**LEBANON PLANNING BOARD
NOVEMBER 13, 2023 - 6:30 PM
COUNCIL CHAMBERS, CITY HALL OR
REMOTE VIA VIRTUAL PLATFORM
LEBANONNH.GOV/LIVE**

Staff Memorandum – PB2023-36-EXT

Mason Storage, LLC, 38 Spencer Street (Tax Map 78, Lot 39), zoned LD: Applicant requests an extension of time per Section 4.10.B of the Site Plan Review Regulations to obtain a building permit pursuant to an approved site plan for a 15,000 sq. ft. addition to an existing storage building, originally approved on October 25, 2021 (PB2021-13-SPR). PB2023-36-EXT

C-201

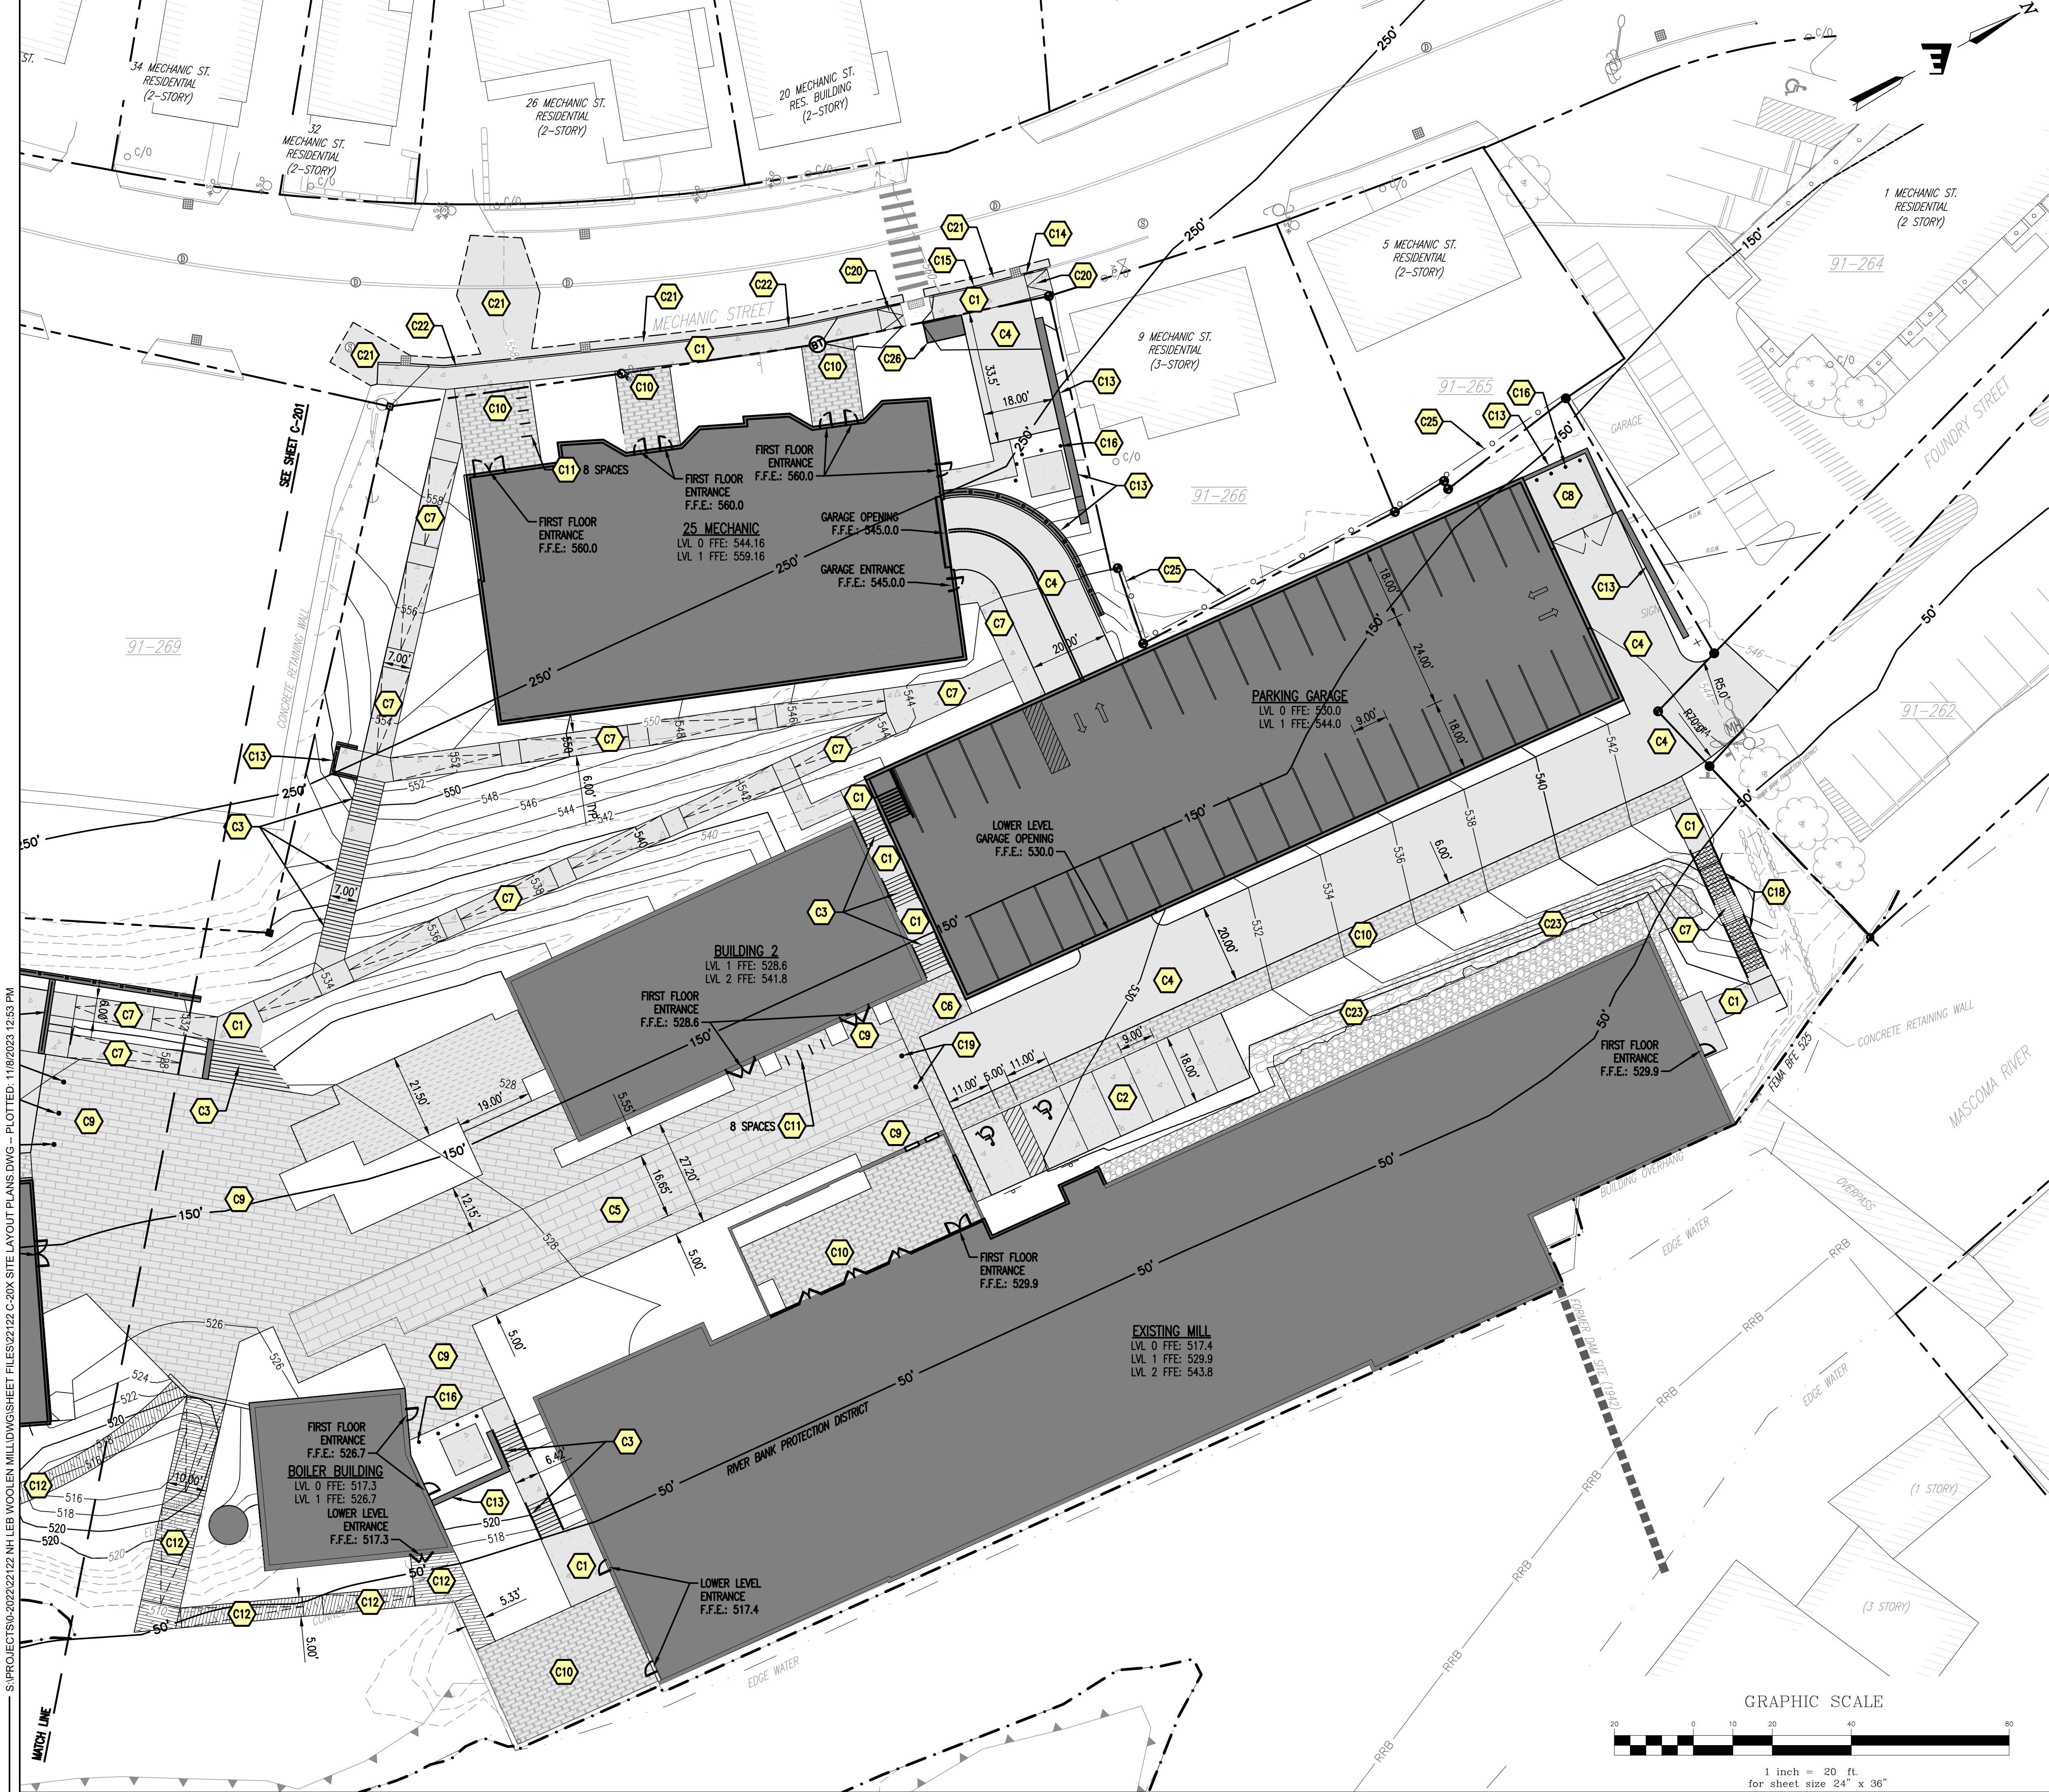
3. Sheet C-202 using symbol (C7) to identify construction of an “ADA accessible route consisting of cast-in-place concrete ramps and landings with handrail” immediately north of the Existing Mill. Since the work so labeled is situated between two consecutive flights of exterior stair identified by symbol (C18) we suspect work identified by use of symbol (C7) may be mislabeled. We recommend Sheet C-202 be rechecked.

C-302

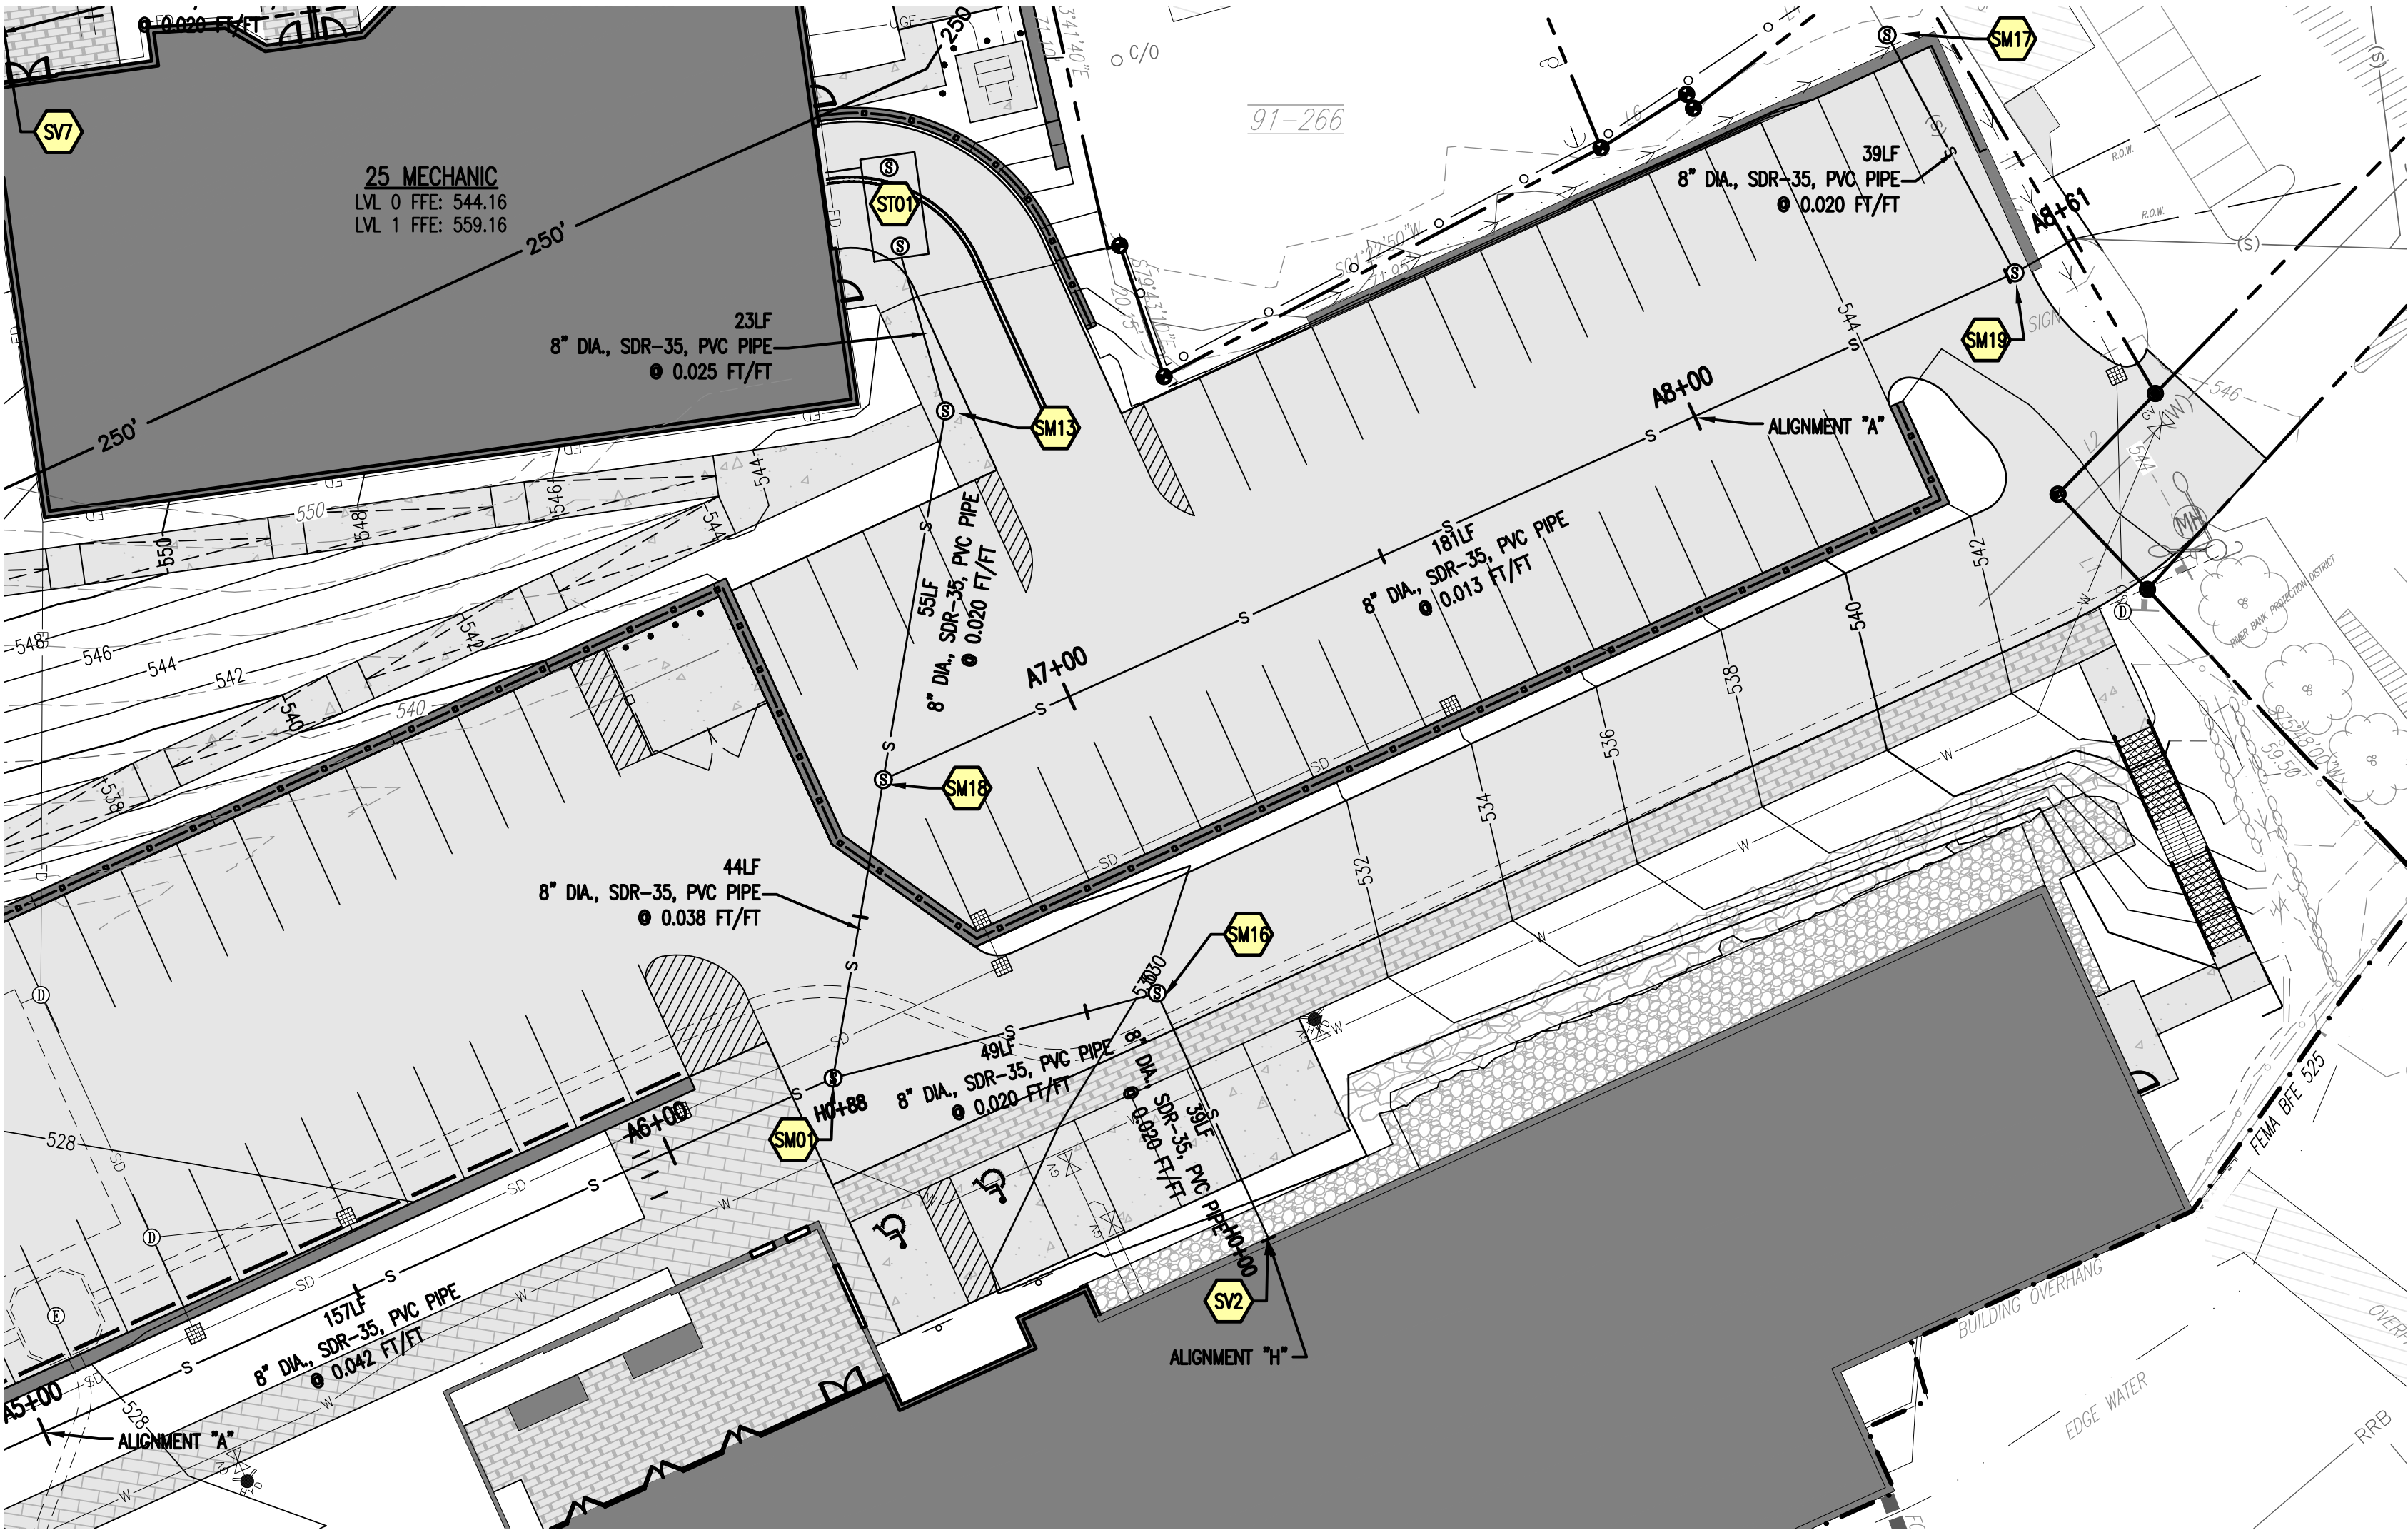
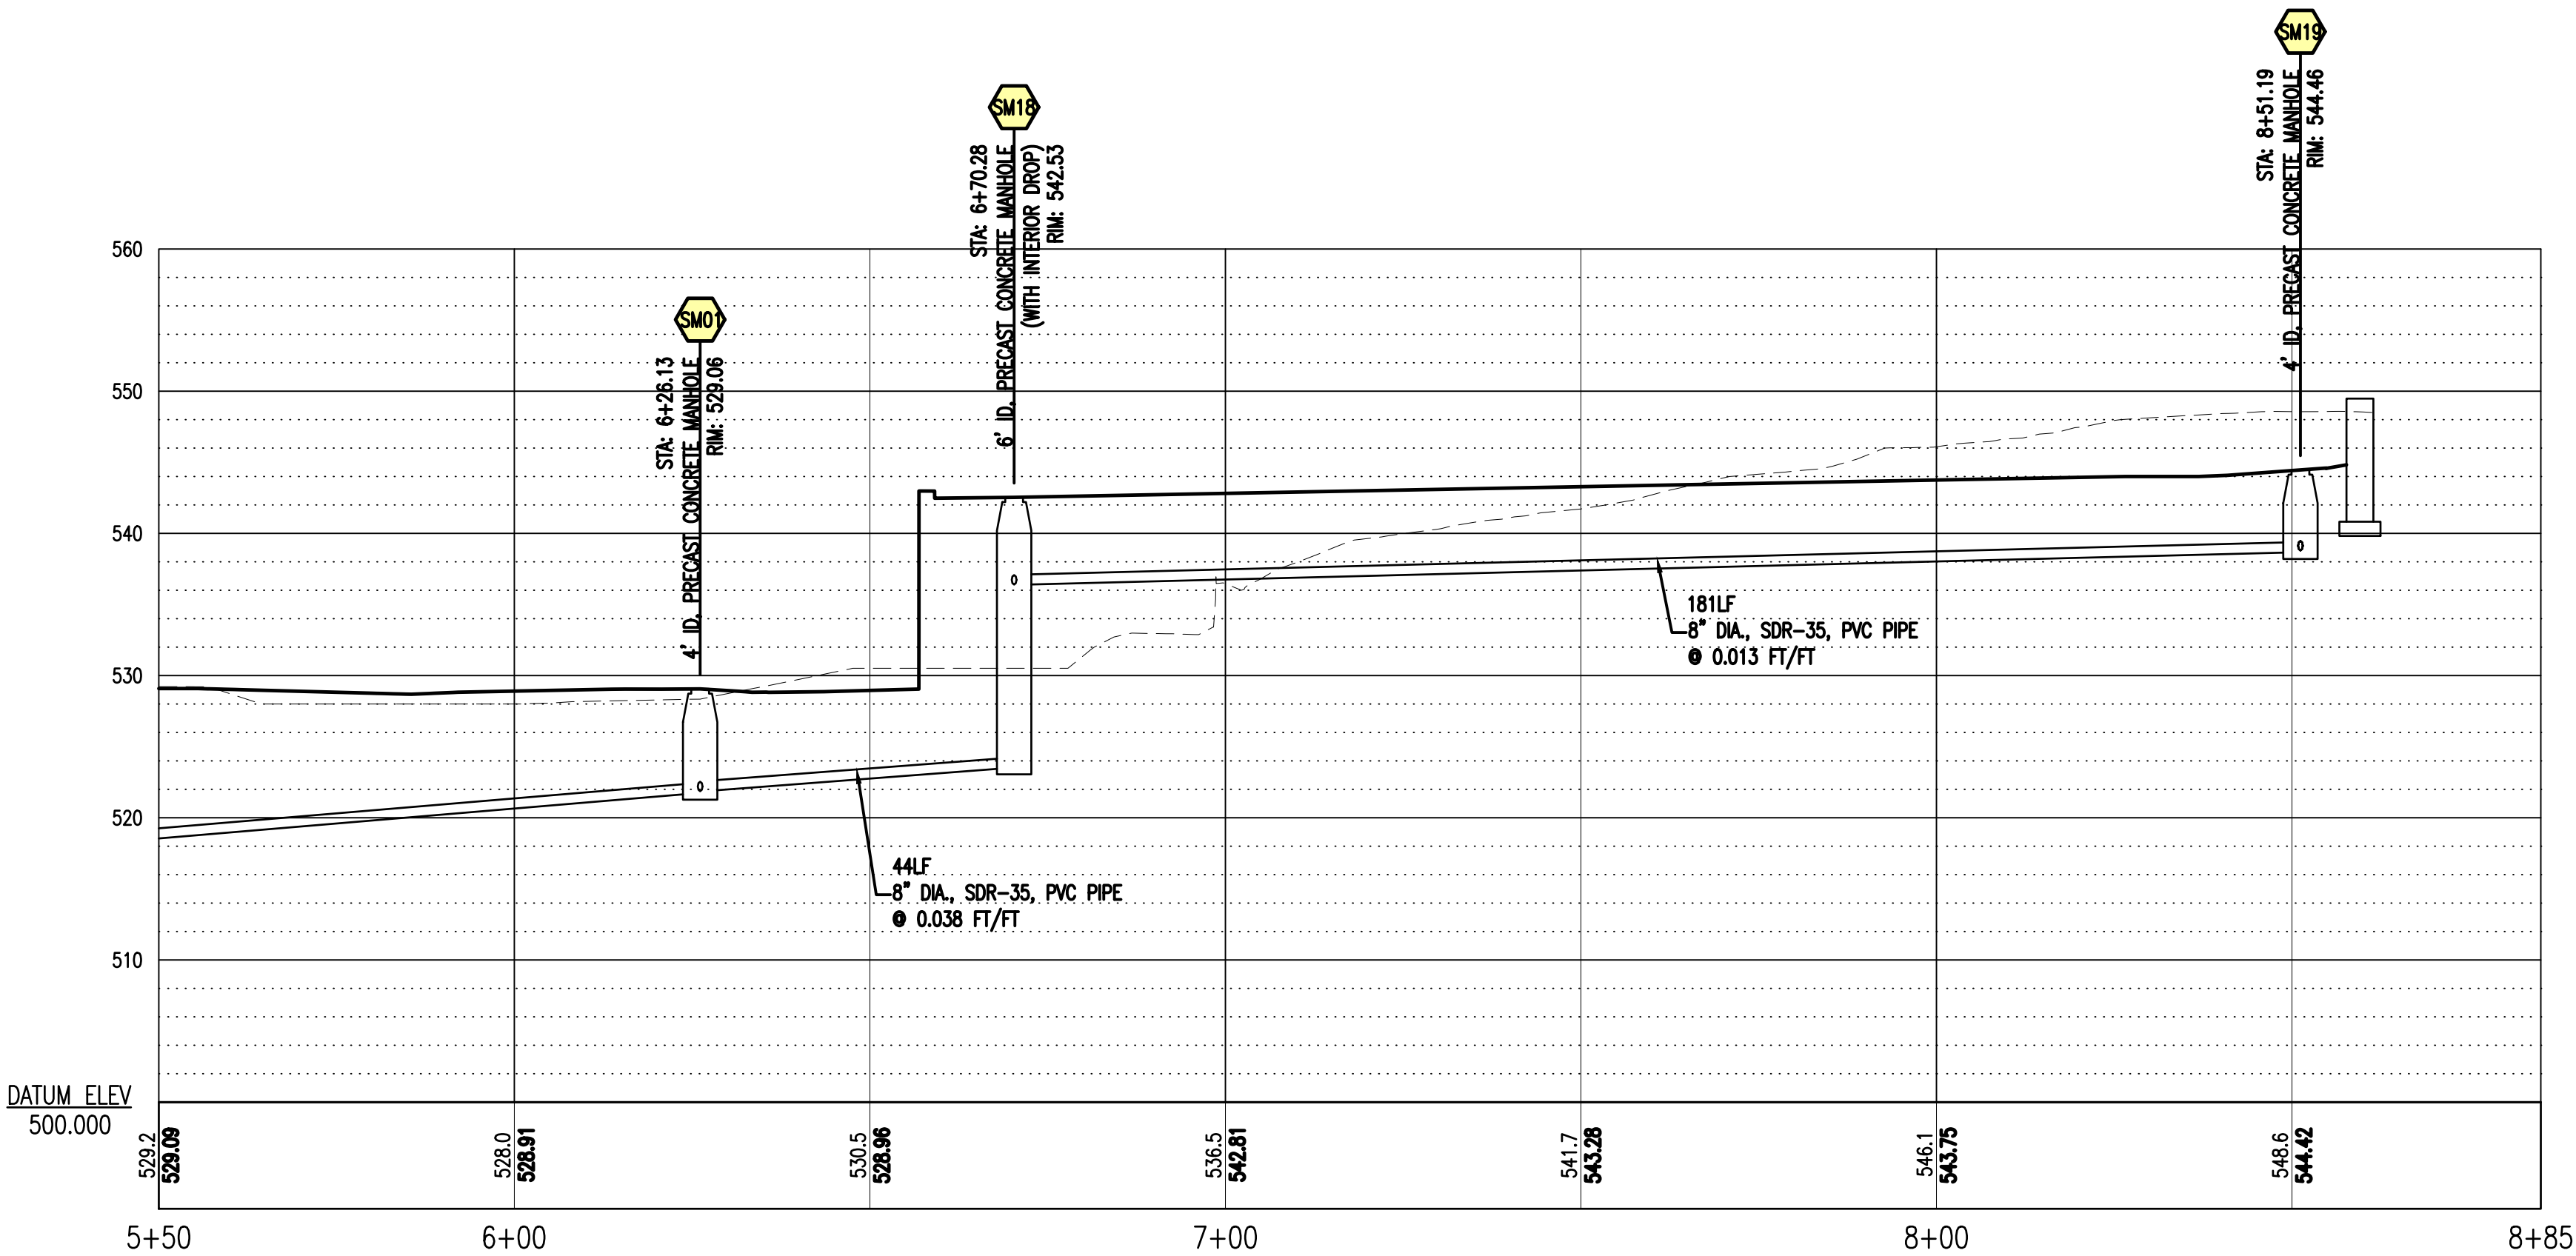
2. We recommend expansion of the Table of Contents, provided on Sheet C-000, to list Sheet C-302 (Sewer Plan and Profile - 1 of 3) included with the current drawing submittal.
